UNITED STATES ARMS CONTROL AND DISARMAMENT AGENCY,  
WASHINGTON, DC, DAN FENSTERMACHER  
PAGE 1 OF 13

COMMENTS ON DRAFT PEIS ON DISPOSITION

Storage and Disposition of Weapons-Usable  
 Flexible Materials Draft PERS

Figure 5-3. Surplus Plutonium Disposition Alternatives.

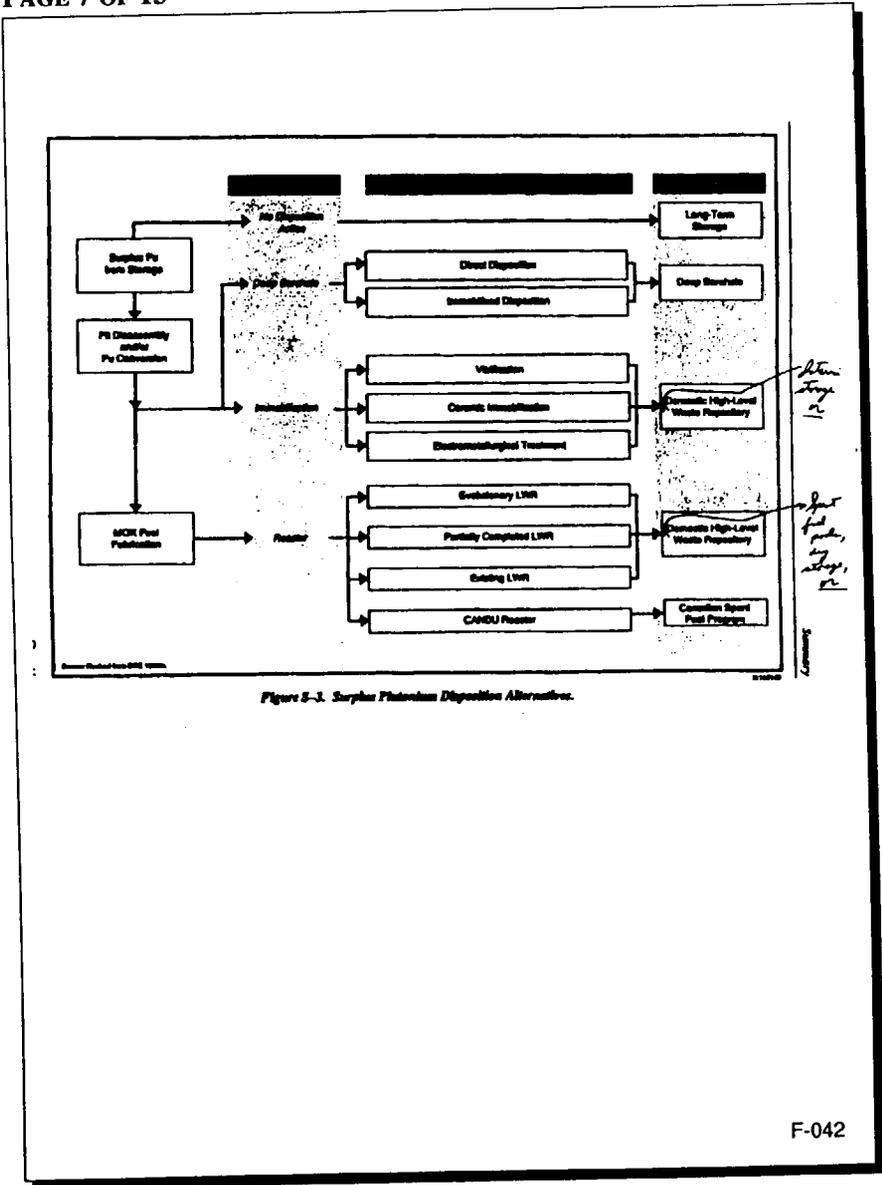
3. Finally, the "destinations" at the end of the disposition alternatives in the figure on p. S-11 are confusing.

Since the figure gives the destination "Domestic High Level Waste Repository" for Immobilization and Reactor options, but "Deep Borehole" for the deep borehole option, it implies that the PEIS is comparing the immobilization and reactor options all the way through to the final repository. I had understood this not to be the case, but rather that the options were being compared only through the achievement of the "spent fuel standard," which is achieved during "interim" storage of the vitrified forms or in spent fuel pools (or dry storage) for the reactor options. This figure should not imply that the more difficult problem of ultimate repositories is being addressed in the comparison as well. I've proposed a wording fix in the margins.

Comment noted. This figure has been modified to clarify that the NWPA-HLW repository is not included in the scope of the environmental analysis.

Figure S-15. Maximum Direct Employment Generated by Disposition Alternative.  
 (generally consider a positive impact, in contrast to the previous subject)

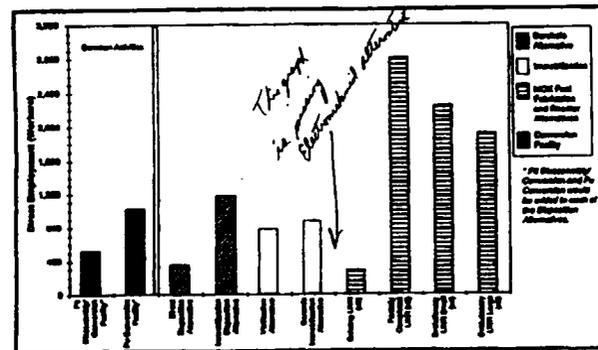
only graph  
 in  
 report  
 all other  
 are  
 not  
 (perhaps  
 could  
 be  
 added  
 to  
 caption)
